EAST ROSWELL LIBRARY
ADDENDUM NO. 09.1-2
APRIL 22, 2013

This Addendum No. 09.1-2 dated April 22, 2013 issued by Ajax Building Corporation of Georgia is hereby made part of Bid Package 09.1 – DRYWALL, FRAMING & STUCCO for the East Roswell Library. The changes and/or clarifications included in this Addendum shall be considered as part of the Bidding Documents and shall supersede, amend, add to, or subtract from those conditions included in the original Bidding Documents, including the Project Bid Package, Drawings, Specifications, previous Addenda, etc. This Addendum must be acknowledged in the space provided on the Proposal Form (included in Section II of the Bid Package). Failure to acknowledge this Addendum may subject Bidder to disqualification.

East Roswell Library

ADDENDUM NUMBER ONE

UTILITY PLAN

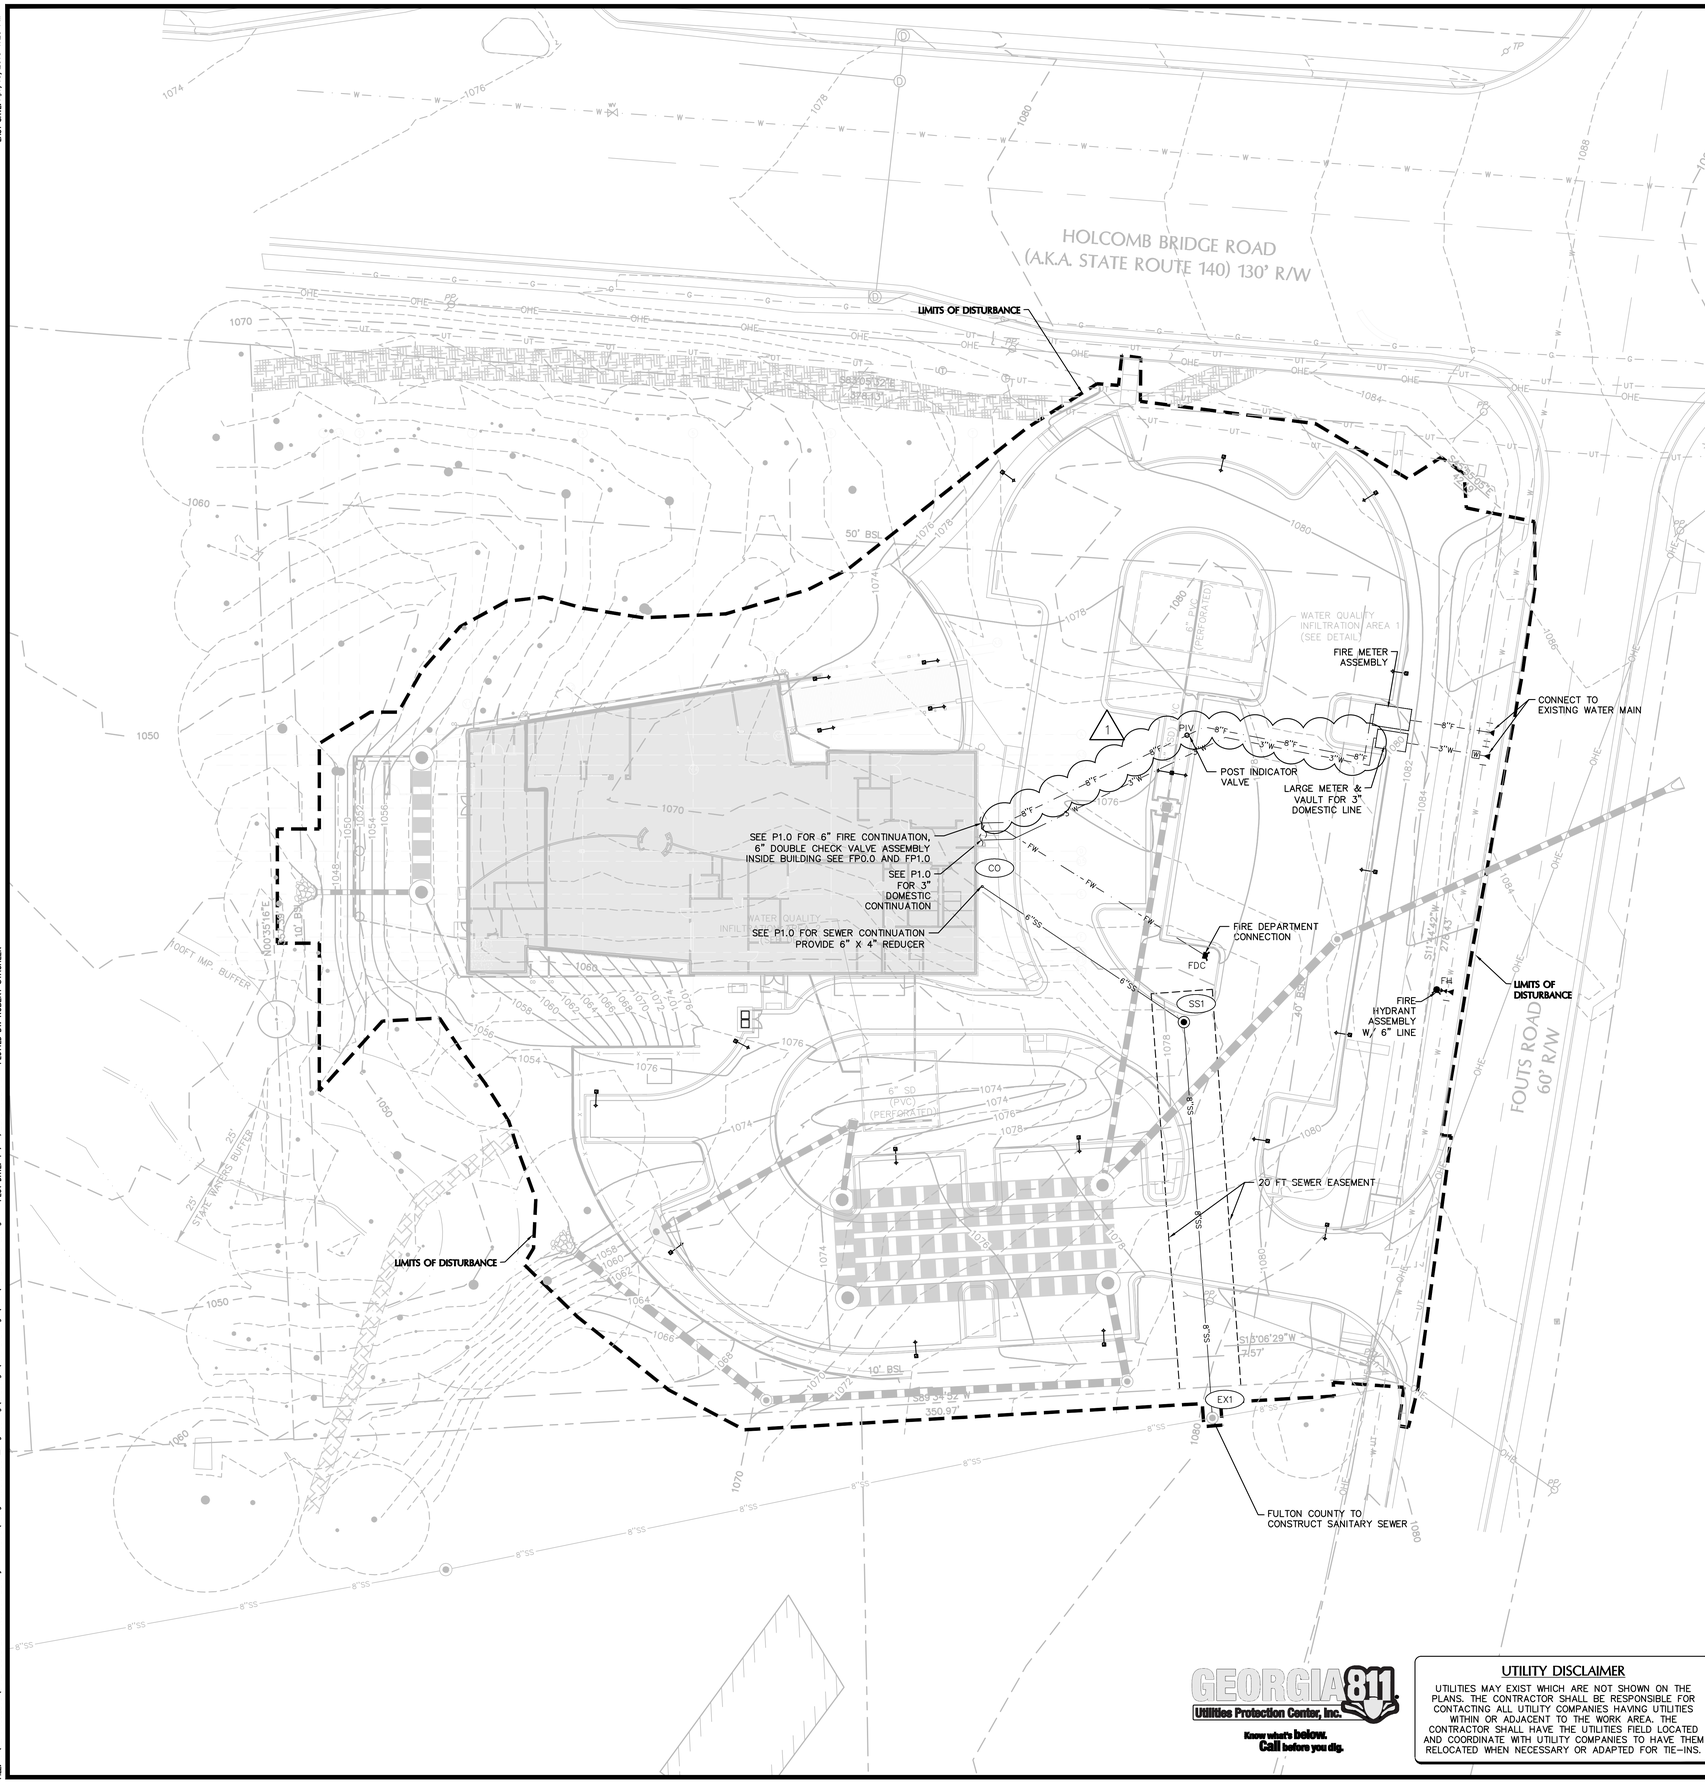
1. The following sheets are issued herewith:
   a. C-500 Utility: delete the sheet and replace with the attached sheet. The fire line between the fire meter assembly and the building has been upsized from a 6-inch line to an 8-inch line.
   b. FP0-0 - Fire Protection Legend, Schedule and Details: delete the sheet and replace with the attached sheet. Detail 4 – Added a 6" tag to the outgoing line on the Double Check Valve Assemblies Detail, DCVA, and changed the incoming fire line size from 6" to 8" on the same detail.

1 BASEMENT FLOOR PLAN - FIRE PROTECTION
1/8" = 1'-0"

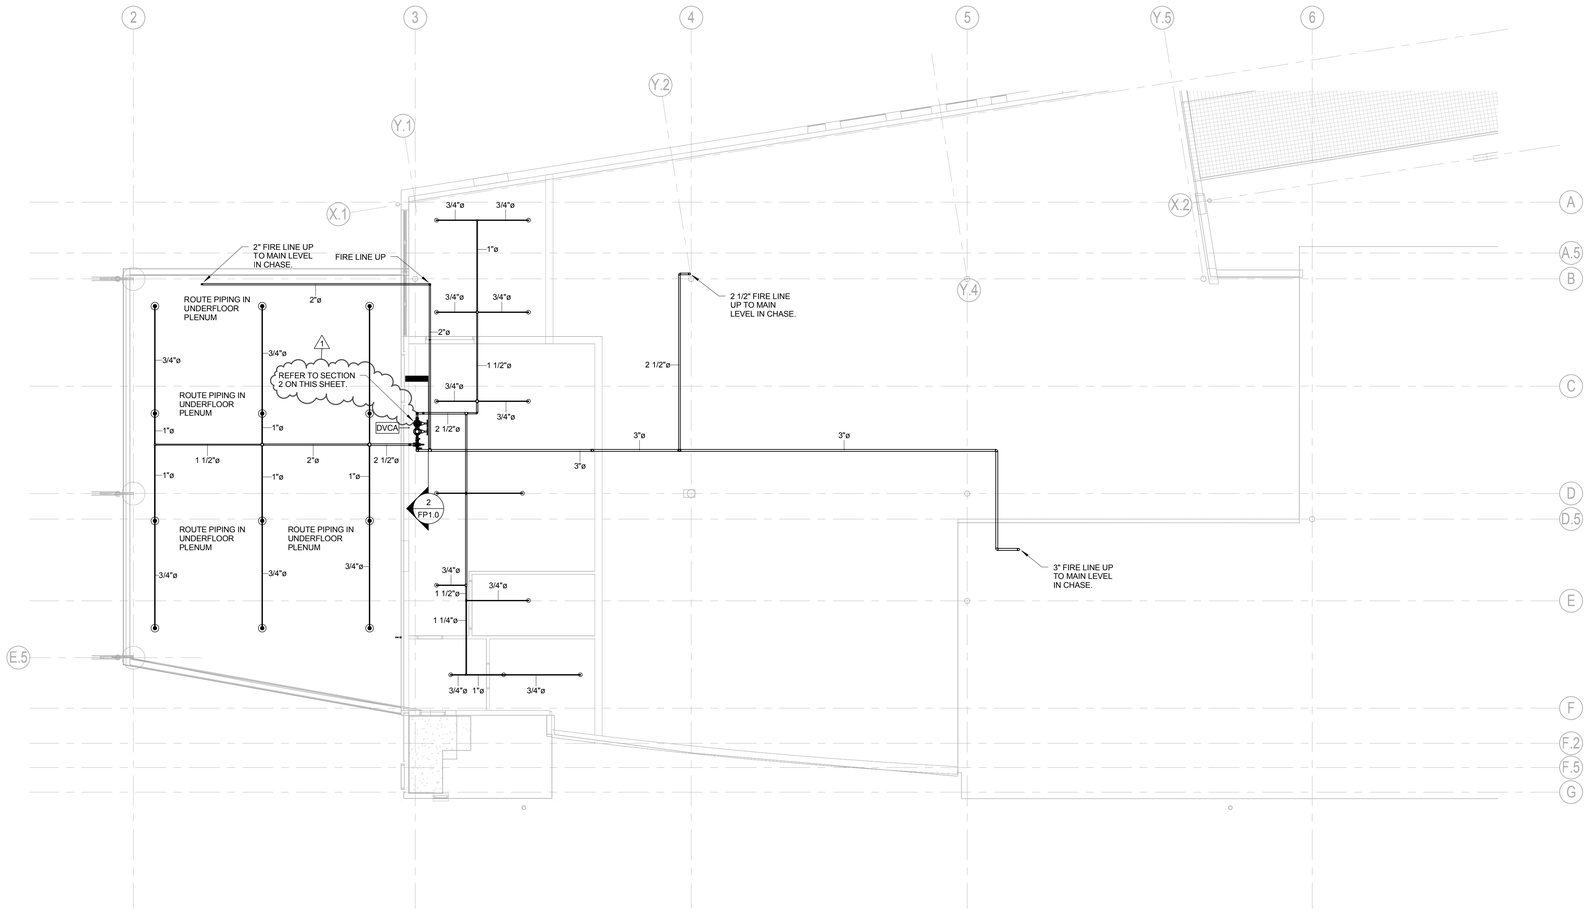
c. FP1-0 - Basement Floor Plan - Fire Protection: delete the sheet and replace with the attached sheet. Plan - Changed the note pointing to the DCVA to read as follows: "Refer to Section 2 This Sheet."
